1998 - 2002 Corvette: Service Bulletin: Audible Spark Knock (Detonation), MIL Illuminated, DTC P0332 Set

Subject: Audible Spark Knock (Detonation), MIL Illuminated, DTC P0332 Set (Replace Rear Bank Knock Sensor and RTV Area Around Sensor)

Number: 02-06-04-023

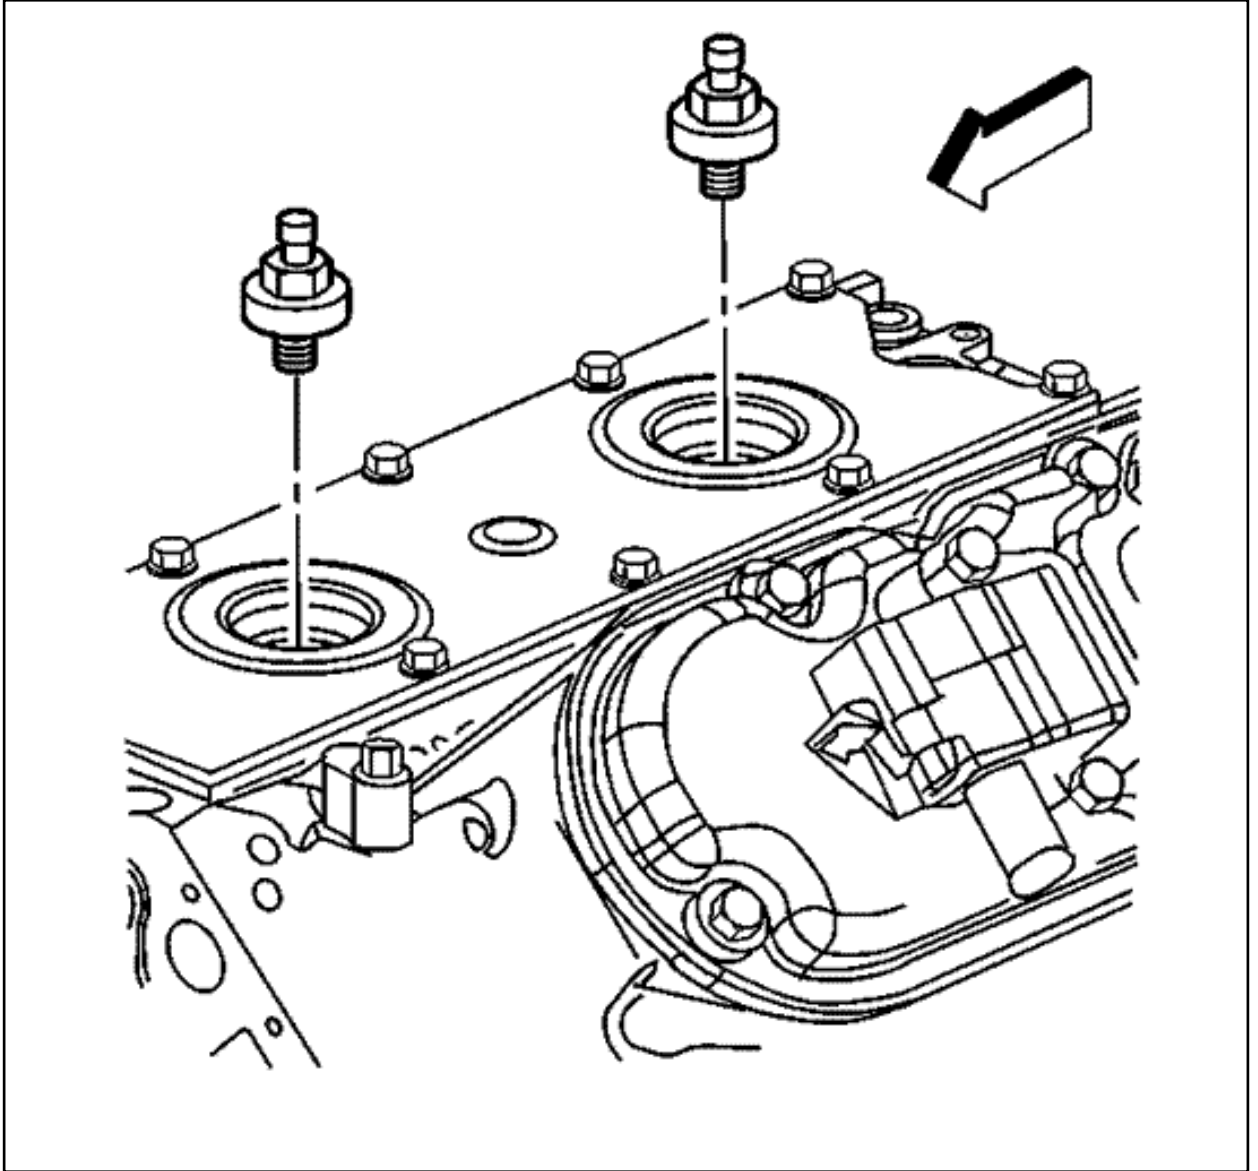
- Remove the intake manifold. Refer to the Intake Manifold Replacement procedure in the Engine Controls sub-section of the appropriate Service Manual.

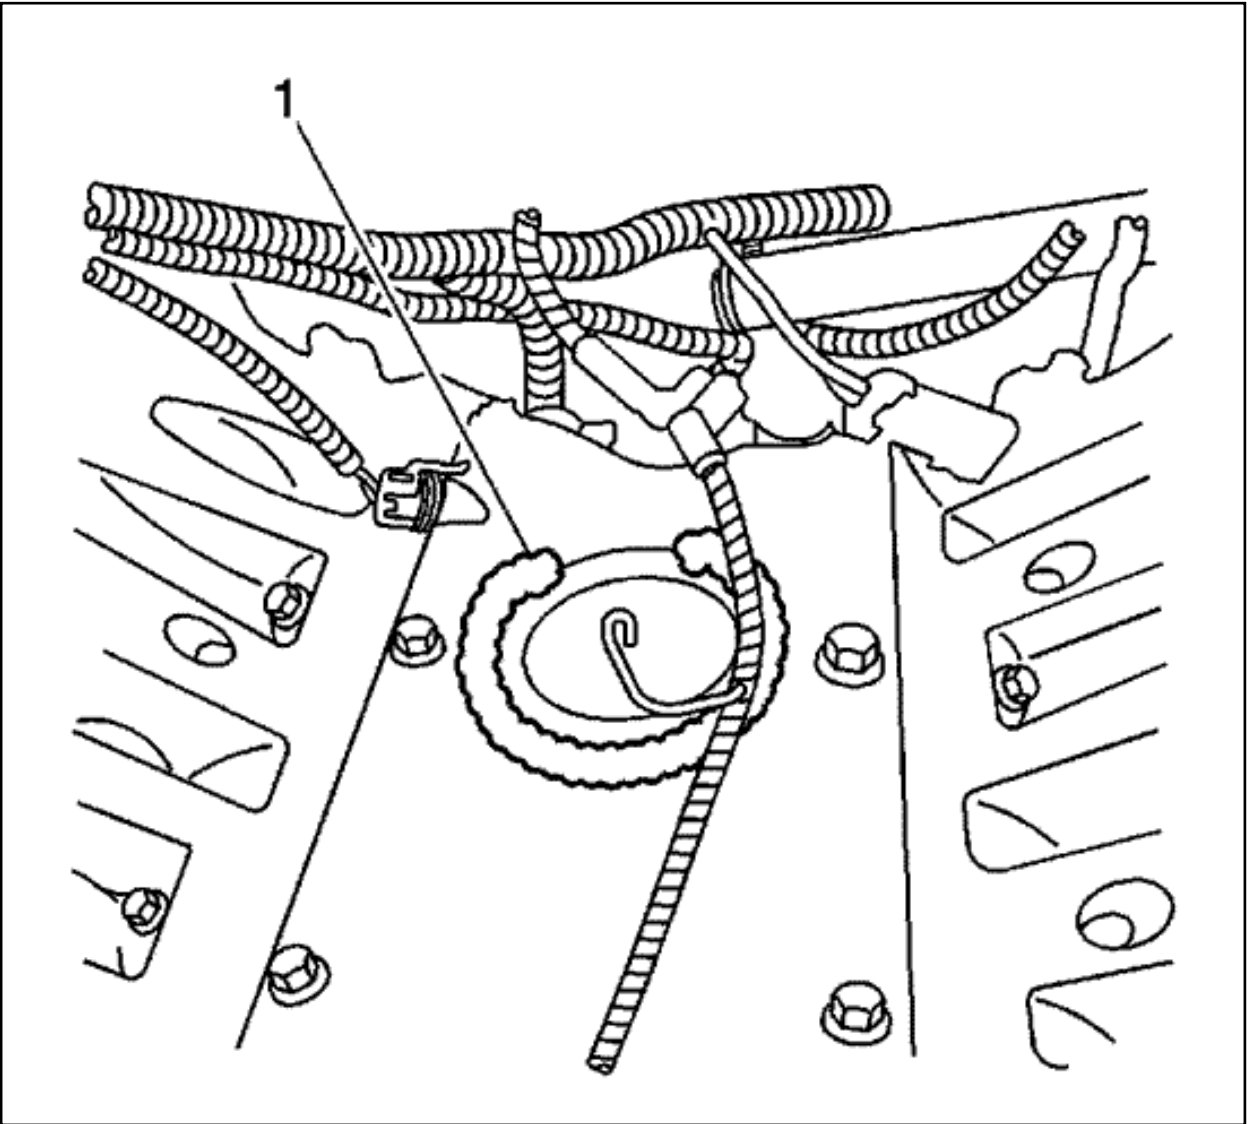
- Remove the wiring harness assembly from the knock sensor.

- Remove the rear bank knock sensor.
- Install the new rear bank knock sensor. **Tighten** the knock sensor to 20 N·m(15 lb ft).
- Install the wiring harness assembly to the knock sensor.
